Review and Comment on proposed addition to the Mission Branch Library

Architectural Review Committee (ARC) of the Historic Preservation

March 11, 2020

The Planning Department (Department) requests review and comment before the Architectural Review Committee (ARC) regarding a proposal for 300 Bartlett Street (Assessor's Block 6515, Lot No. 001) to construct a two-story with sub-grade basement horizontal addition on the west and south facades for use as additional community space and staff facilities, restoration of the historic entry from 24th Street, interior renovations and reconstruction of a central stair based on historic documentation. The subject property is Landmark No. 234 (designated in 2002), also known as the Carnegie Mission Branch Library. 300 Bartlett Street is in a P (Public) Zoning District and a 55-X Height and Bulk District, is currently owned by the City and County of San Francisco and is operated by the San Francisco Public Library.

LANDSCAPE DETAILS FENCE

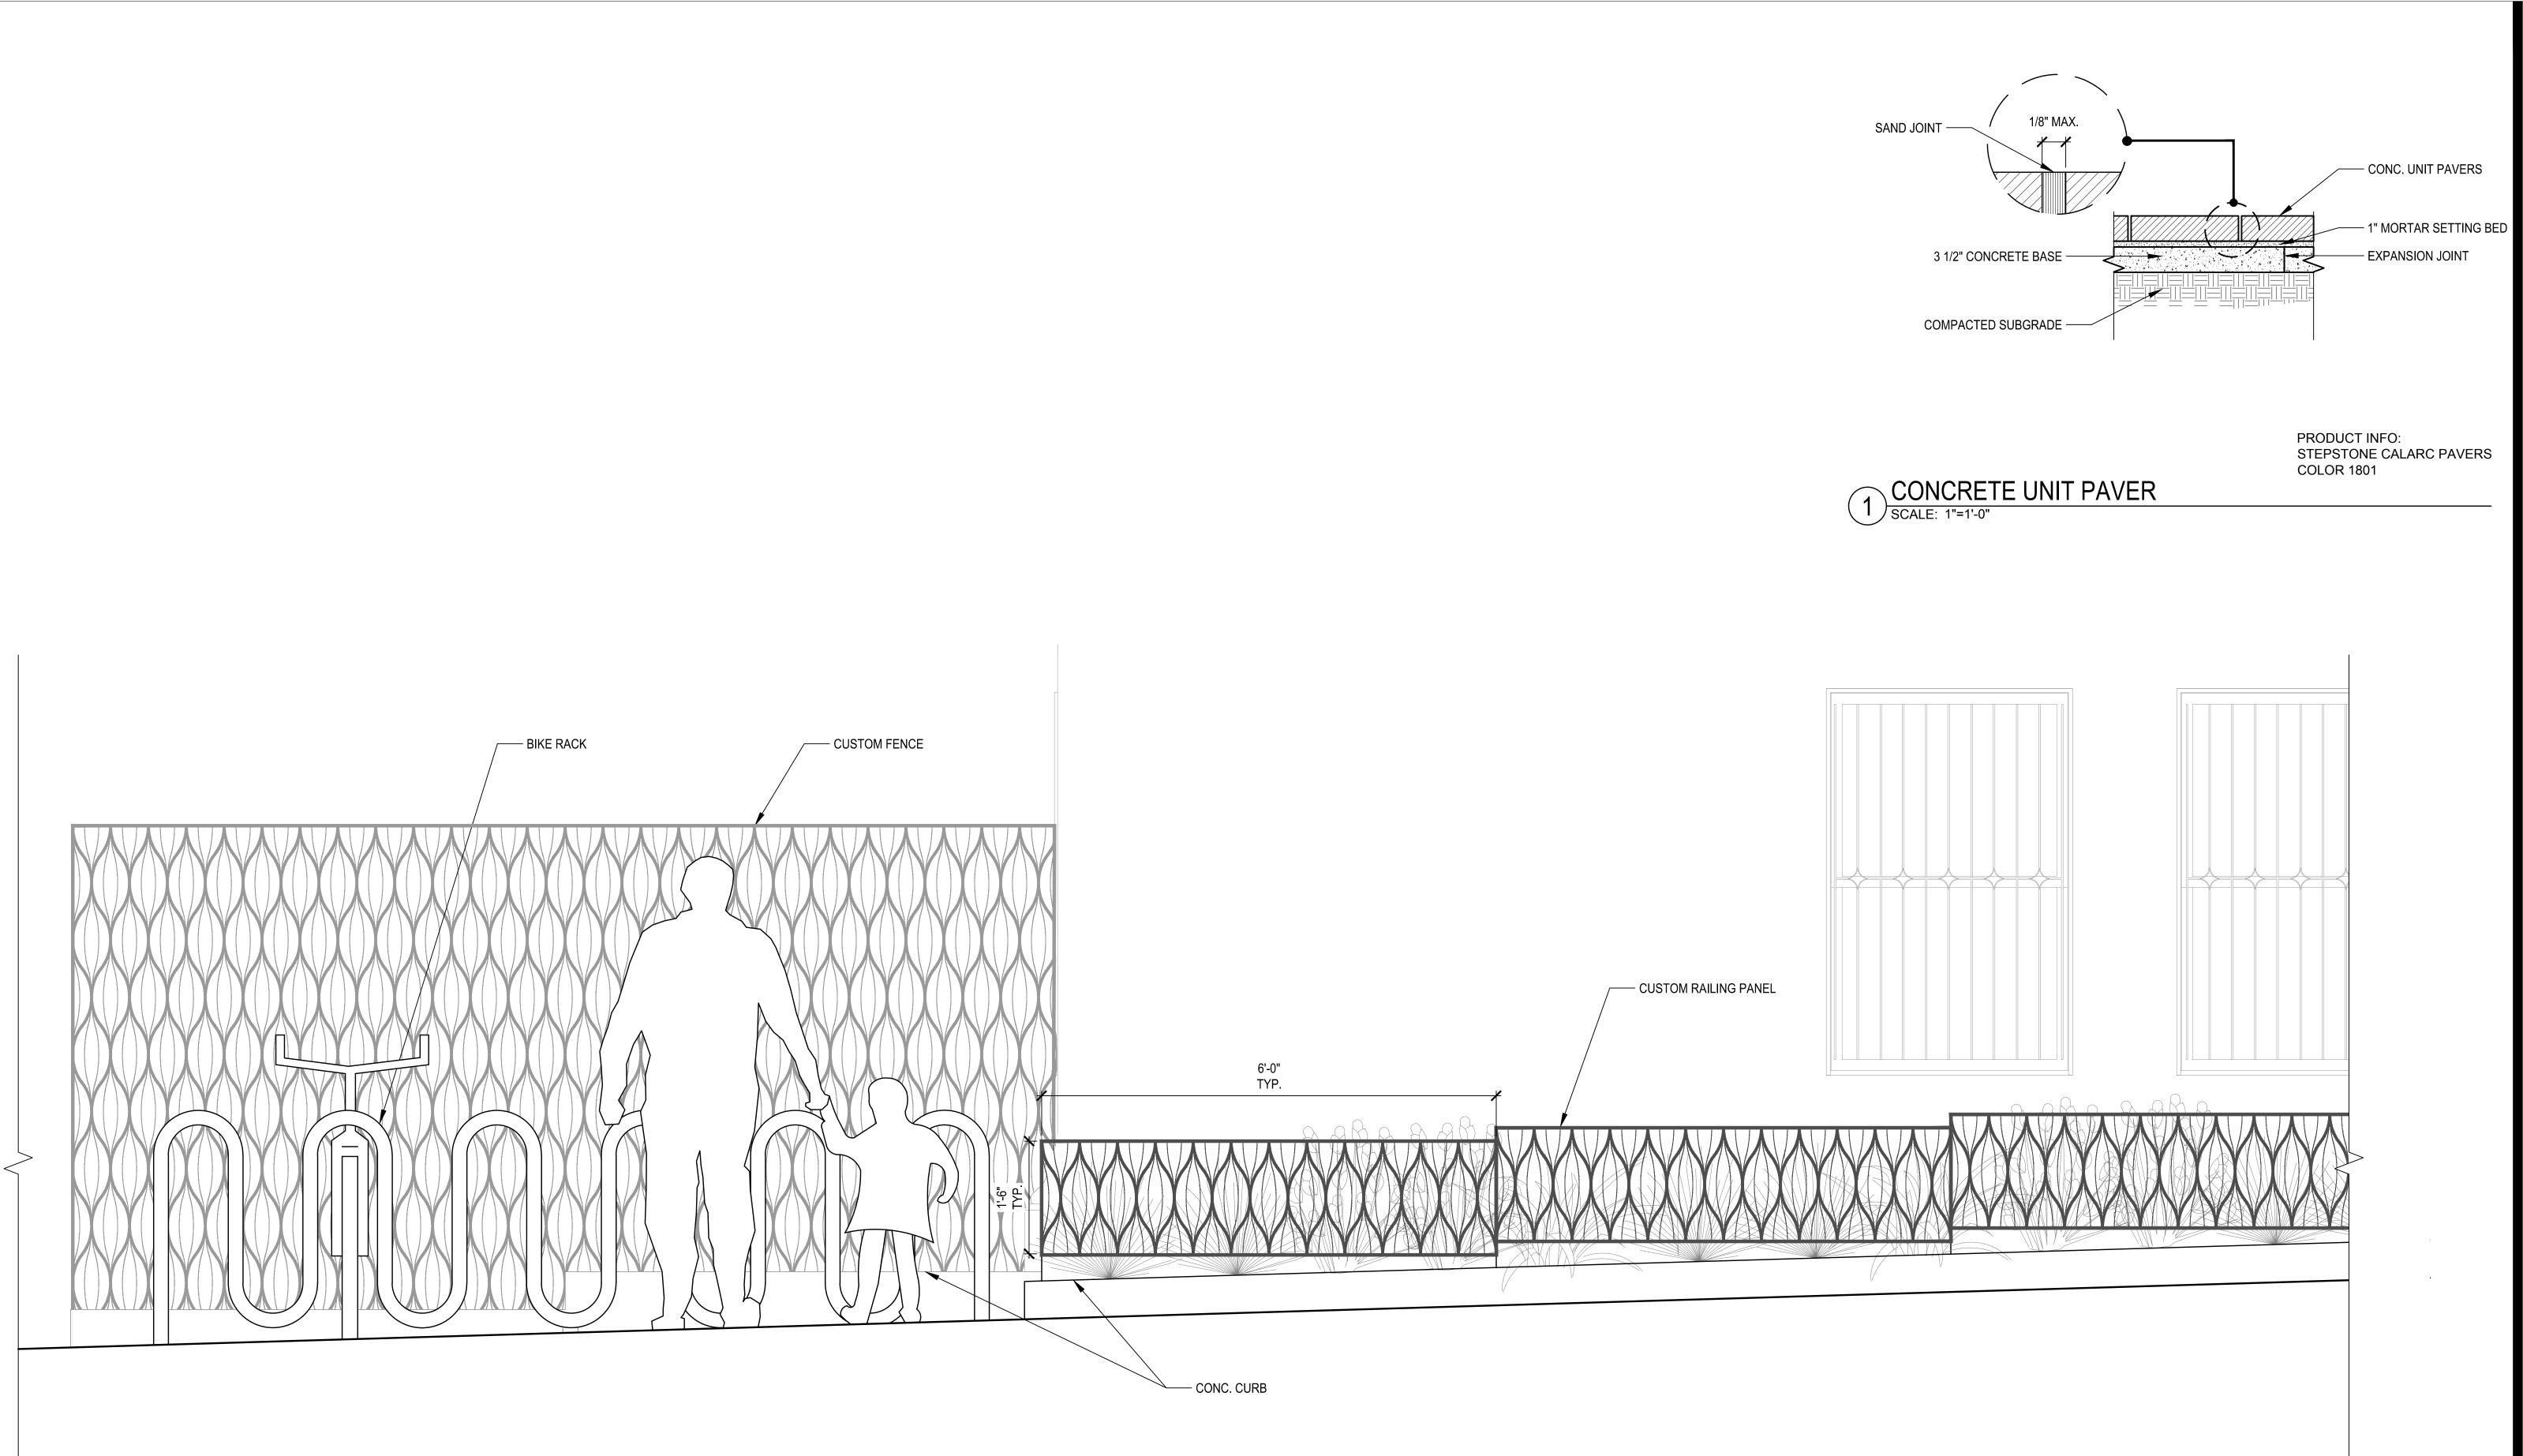
- Landscape and Streetscape along Bartlett Street: The project proposes new landscape and streetscape features along the Bartlett Street side of the property. This will include benches, planters, a six-foot tall fence, and bike racks.

- o Staff Recommendation: Staff requests ARC input on the proposed landscape and streetscape items. Staff is generally supportive of the landscape and streetscape features proposed for the Bartlett Street side but recommends alternatives to the proposed six-foot tall fencing at this side be explored (i.e. shorter fencing) to allow a more open pedestrianlevel experience of the landmark building.

PROPOSED RESTORATIVE ASPECTS OF PROJECT - ENTRY DOORS

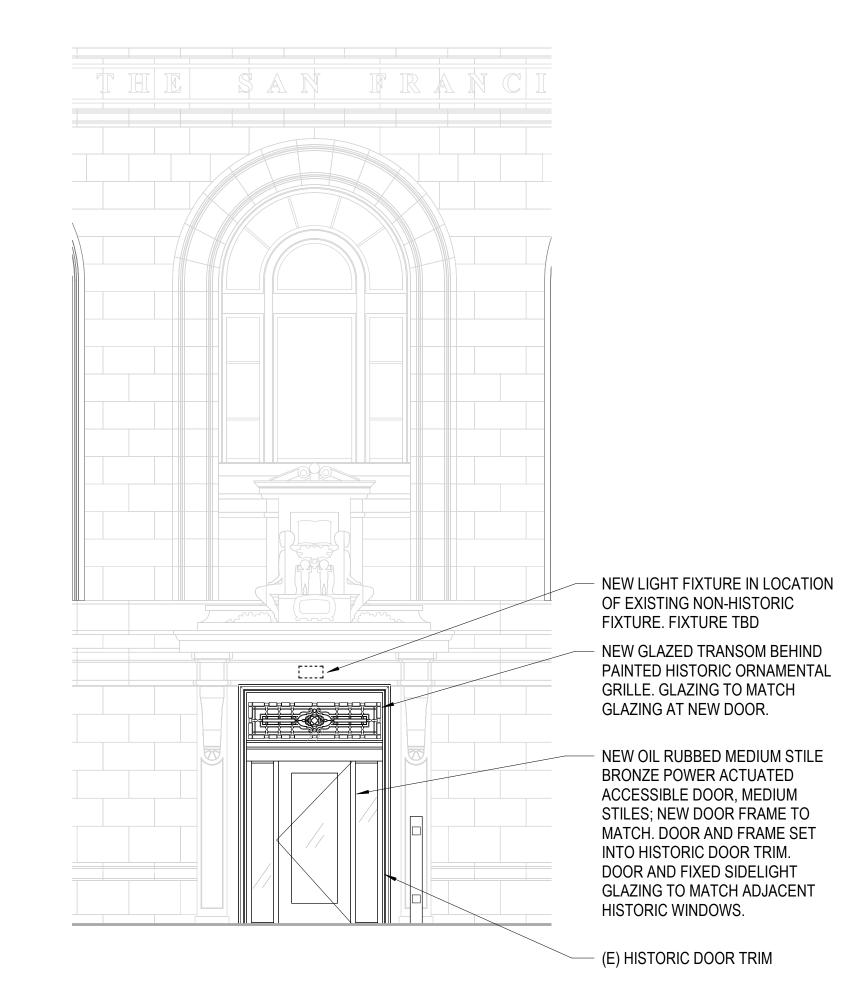
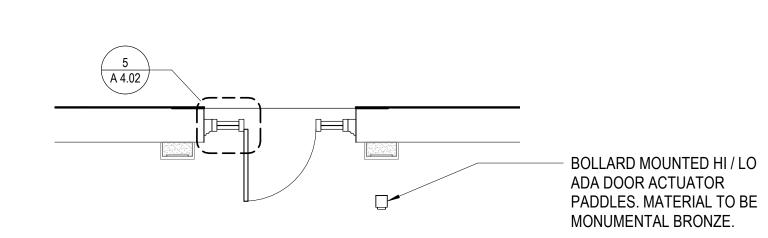
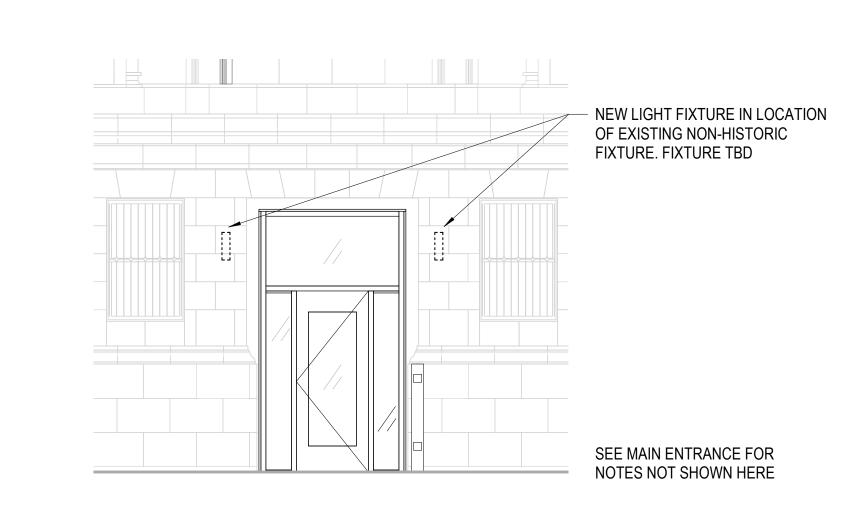
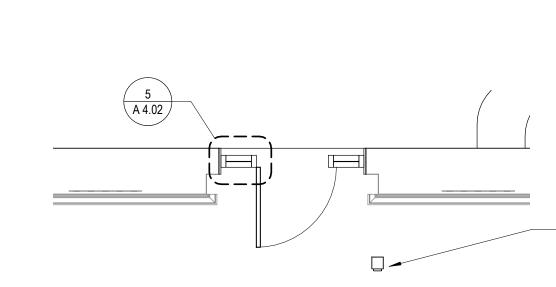
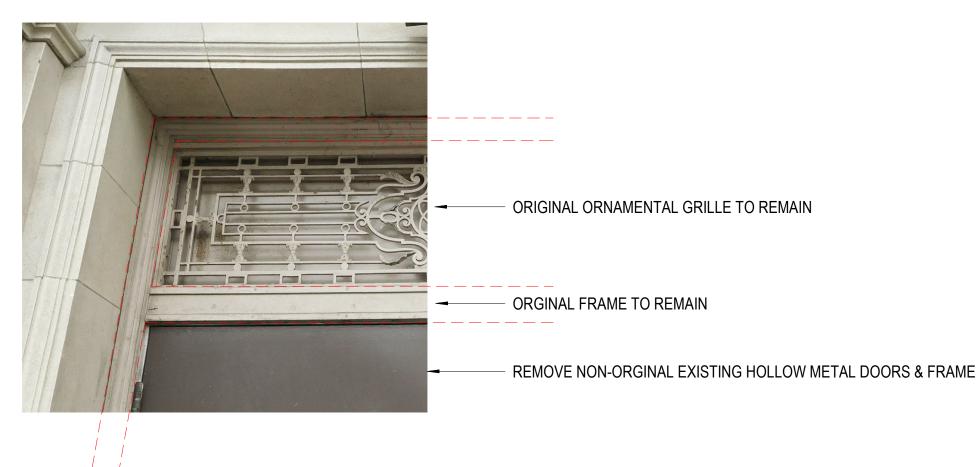
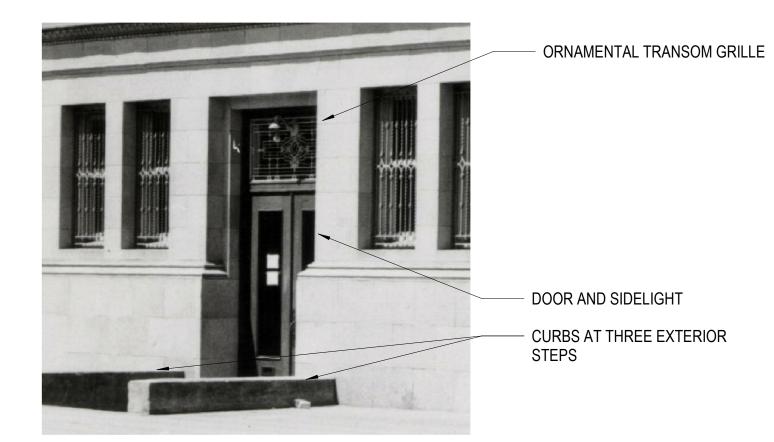
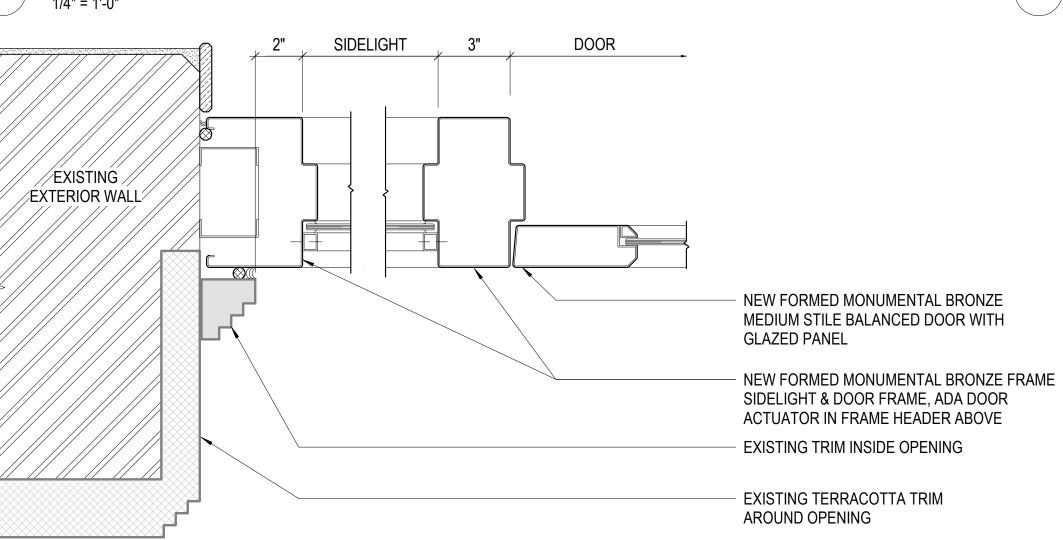
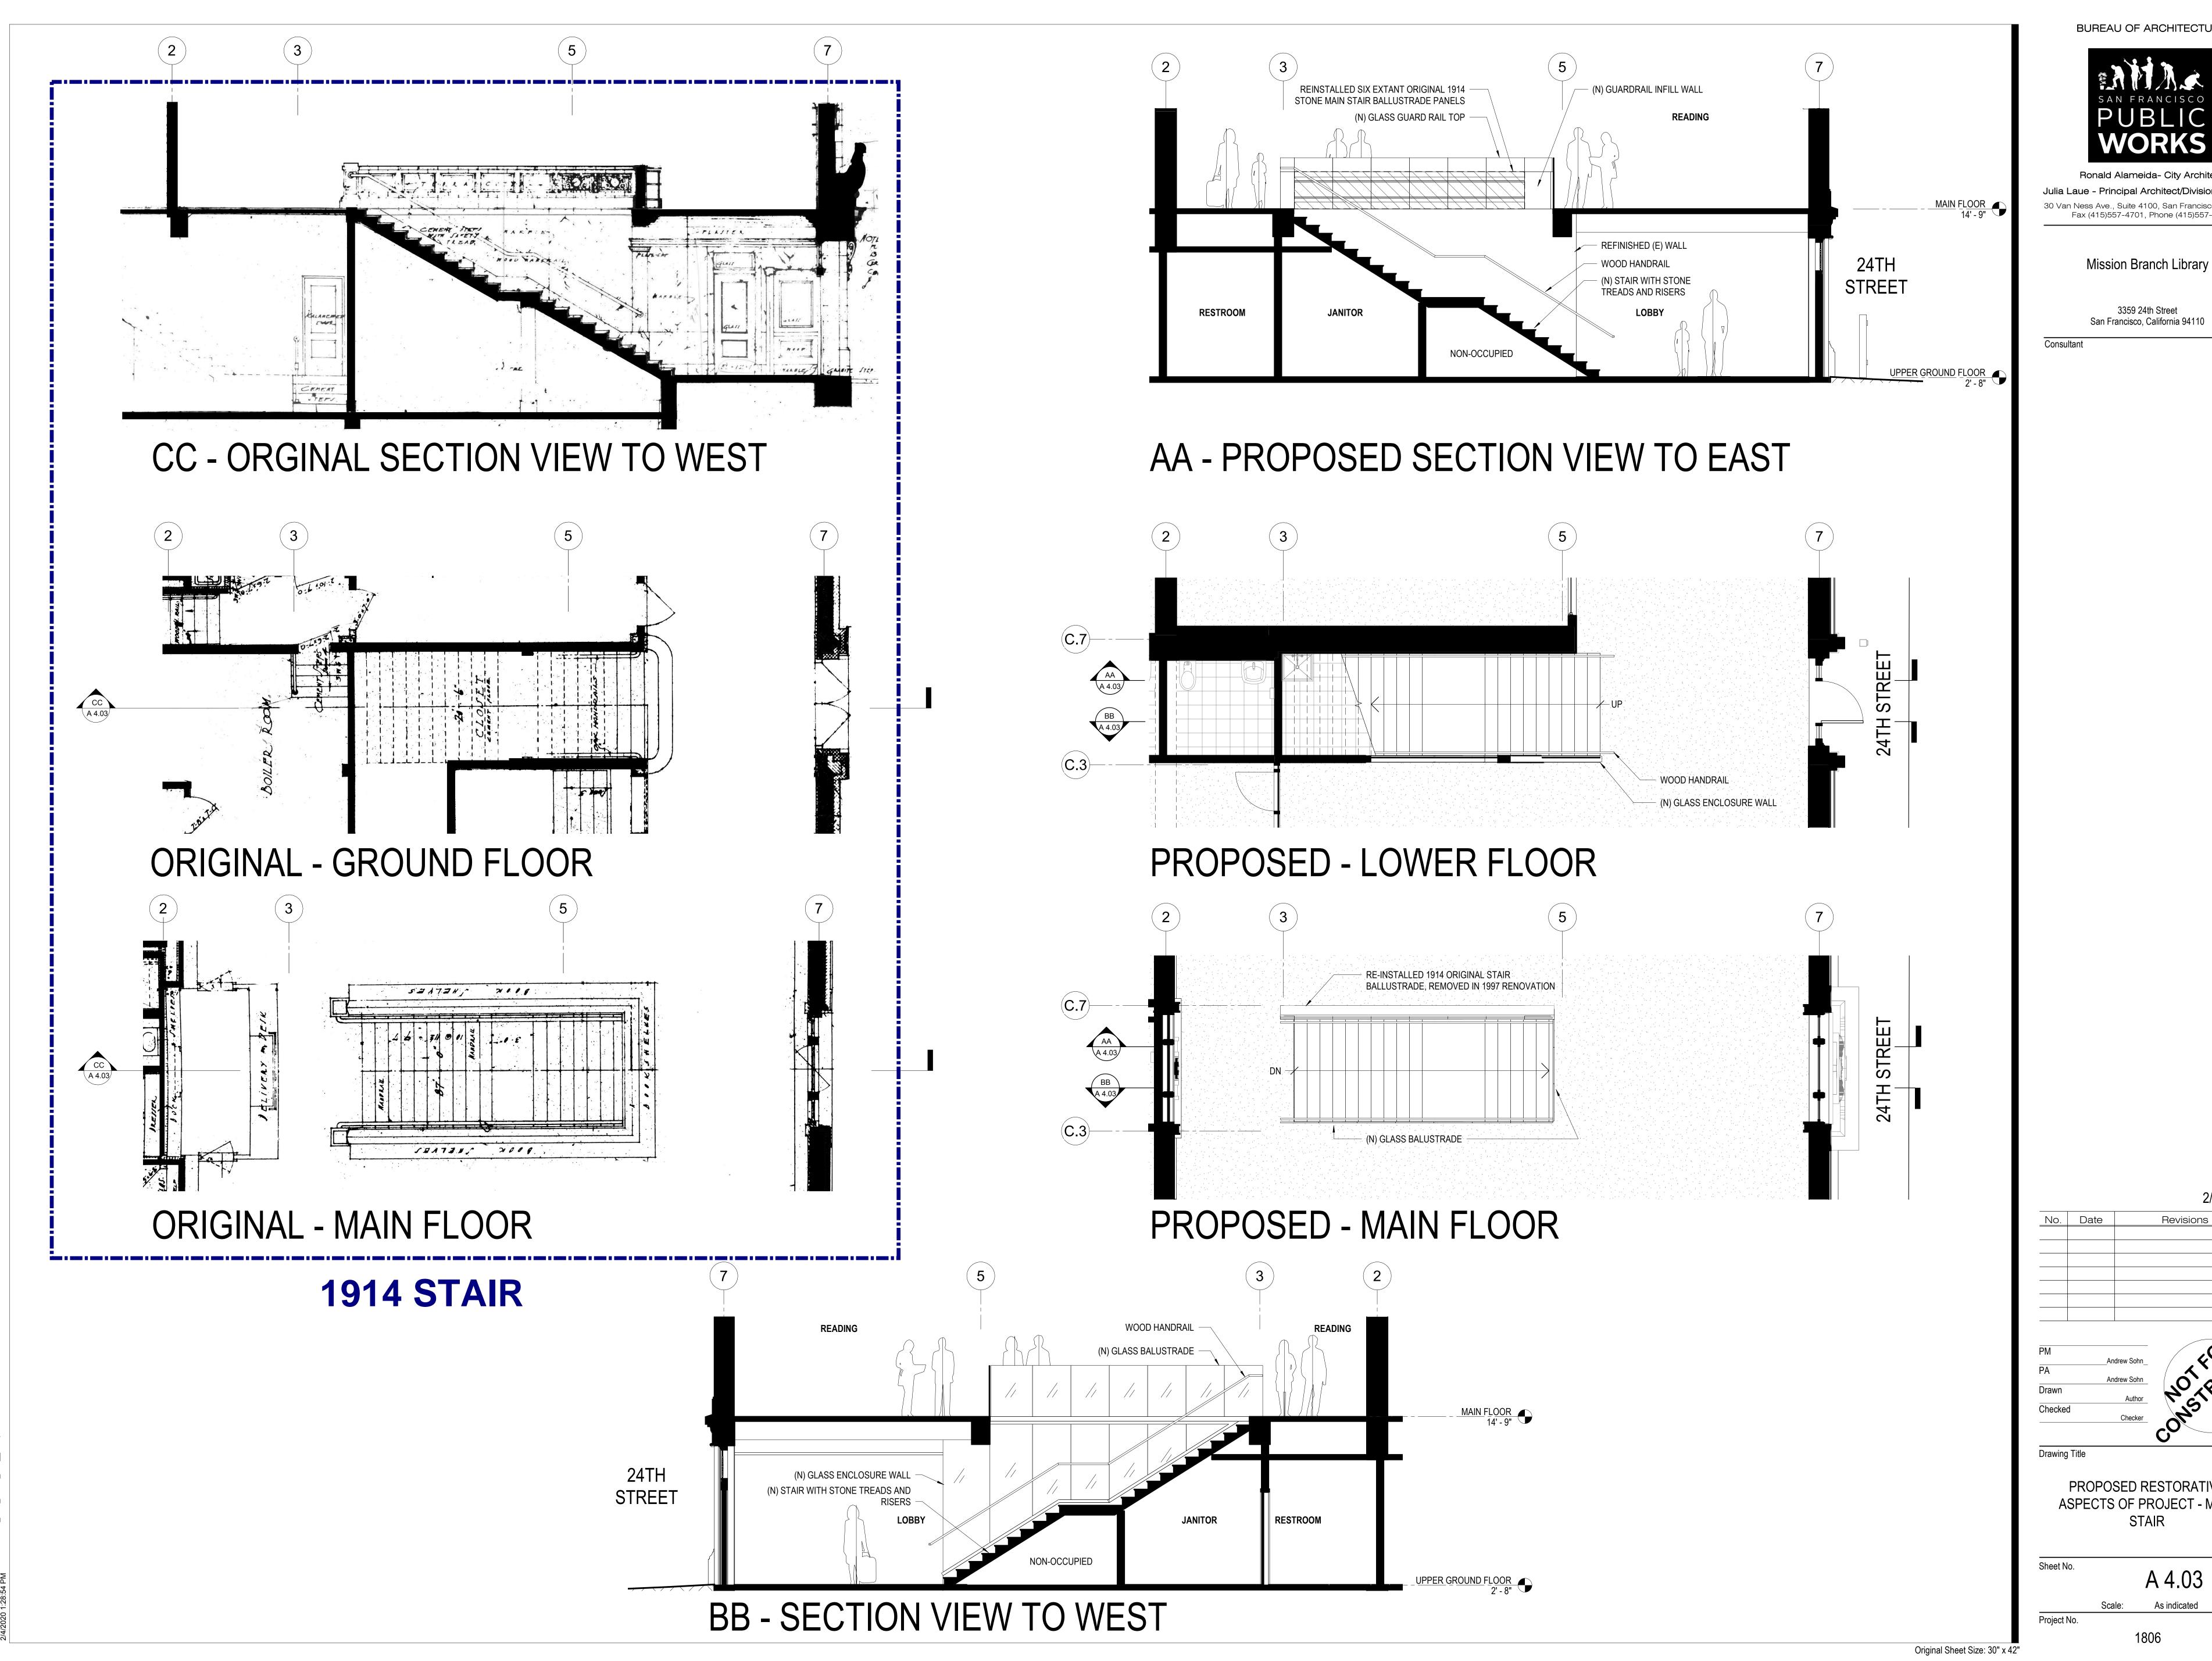
- Restoration of Historic Entry: The restoration of the historic entry facing 24th street will be based on historic photo documentation and will remove the non-historic solid doors and replace them with a single centrally glazed door with two side lights. The existing historic transom grill will remain and new glazing will be installed behind.

- Staff Recommendation: Staff requests input from the ARC regarding the proposed restoration of the historic entry. Staff is generally in agreement with the restorative approach of the historic entry along 24th Street, but requests that a configuration of double doors be explored, rather than a single door with sidelights, which would be more in keeping with the historic configuration.

- 1. More information/details about (e) refinished wood door photos, etc.
- See drawing A3.11 and A4.02 in attached drawing packet. Door will be monumental bronze finished balanced door in a design similar to the original building. We do not have records of the exact original door but have used period photographs to get a sense of the door. ADA requirements require some deviation from original.

- 2. More information on how new bollard/mounted auto door opener will be attached to building can show details in a cross section
- ADA door openers will be bollard mounted (freestanding on the sidewalk), not attached to building. See dwg A4.02.
